ECE/TRANS/WP.29/GRRF/2007/14
16 July 2007

MEETING OF THE GRRF WORKING GROUP

- The amendments agreed at the 2nd meeting of the informal group
- The editorial amendments proposed by USA in doc. GTR-ESC-2007-13
- The amendments and comments from RUS in their mail of 30 October 07
- The amendments proposed by CLEPA in doc. GTR-ESC-2008-05
- The amendments proposed by OICA

Development of the draft global technical regulation on electronic stability control systems
Proposal for a draft global technical regulation on electronic stability control systems
Submitted by the Chairman of the GRRF Working group on Electronic Stability Control

Figure 1. Steering wheel position and yaw velocity information used to assess lateral stability.

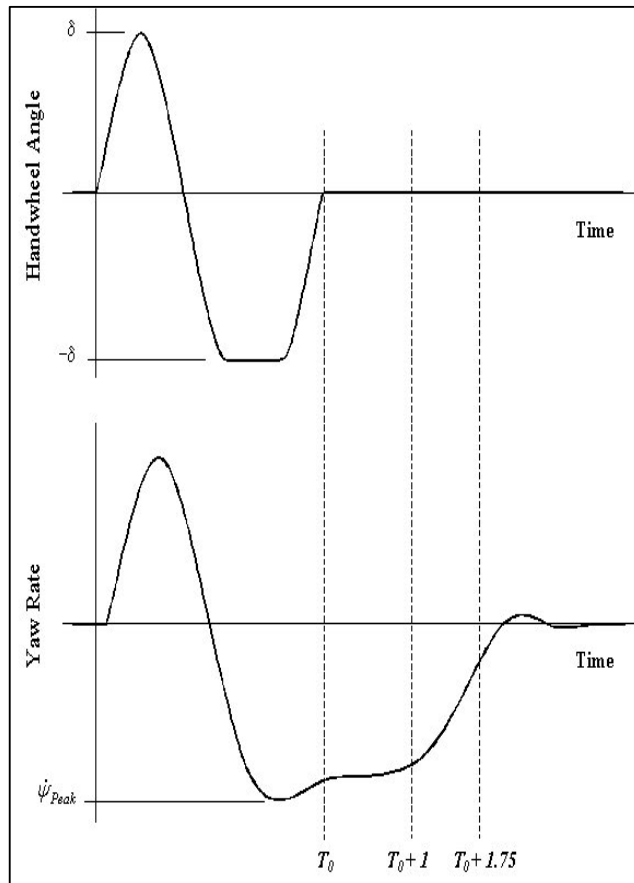
["Handwheel" to be corrected into "steering wheel"]
[Provide "passing" AND "failing" example]
